Commonwealth Edison
Braidwood Nuclear Power Station
Route #1, Box 84
Braceville, Illinois 60407
Telephone 815/458-2801

Subject: Teleconference between Commonwealth Edison Company and the
Nuclear Regulatory Commission dated October 3 and 4, 1995,
Regarding the Increase in the Interim Plugging Criteria for Byron
Unit 1 and Braidwood Unit 1
NRC Docket Numbers:50-454 and 50-456

Attachment

**MODEL D4
TOP PLATE**

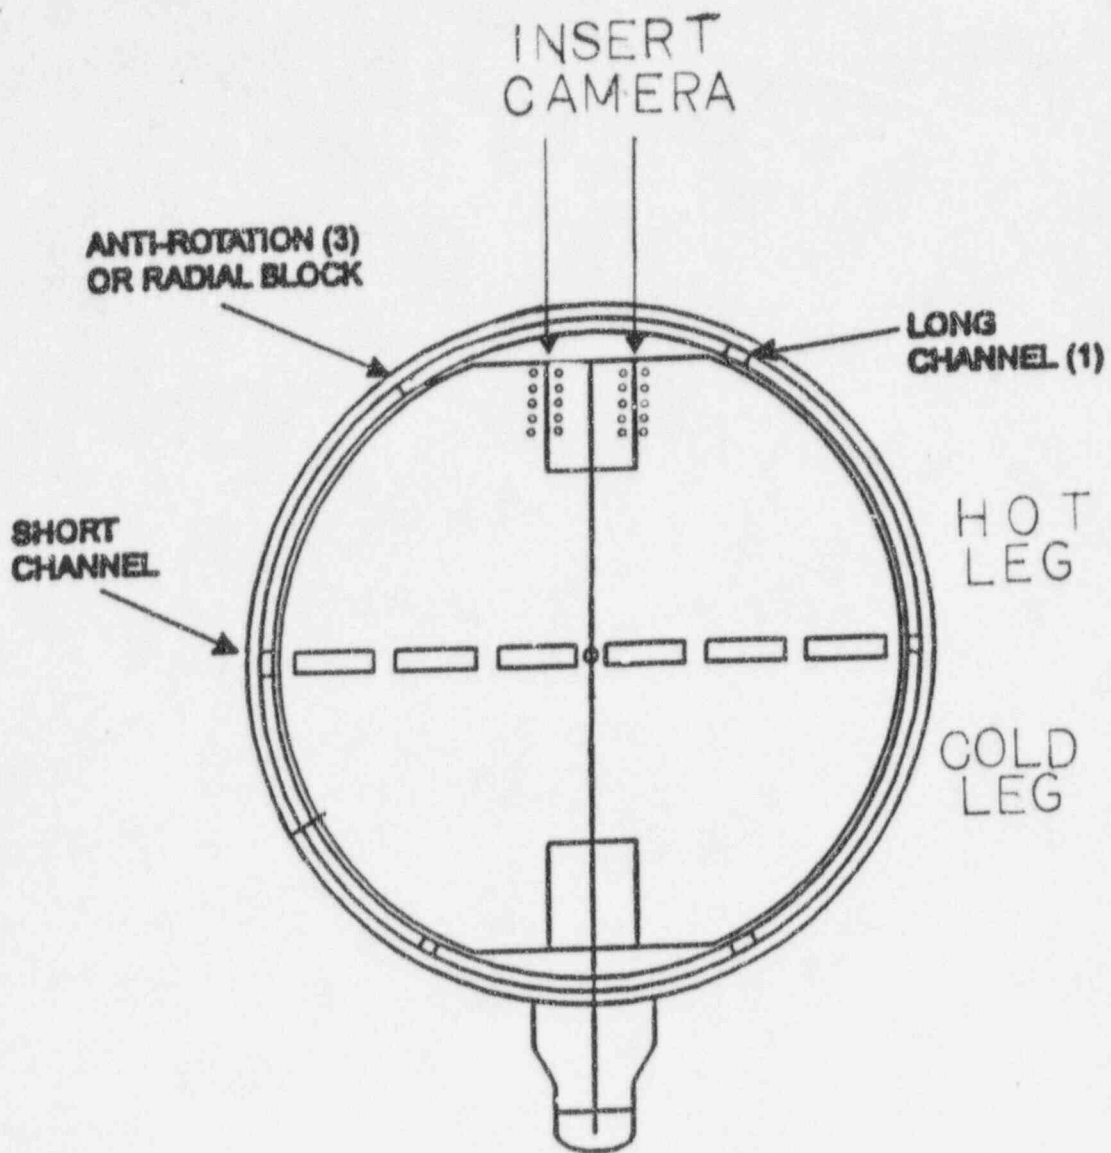
During the Braidwood Unit 1 refueling outage a visual inspection of the "A" SG top TSP patch plate area will be performed. The inspection will consist of inserting a camera along the 2 accessible patch plate seams to a distance of 5 tube rows (see attached sketch). This visual inspection is intended to determine if TSP degradation is present in this area. Those TSP intersections that have received visual inspection (20 tubes), will also be eddy current inspected and data analyzed using techniques and analysis guidelines developed through the EPRI program to detect TSP degradation. The eddy current responses seen in the SG will be compared to those obtained in the EPRI mockup and any ambiguous signals will be investigated and reported to the Staff.
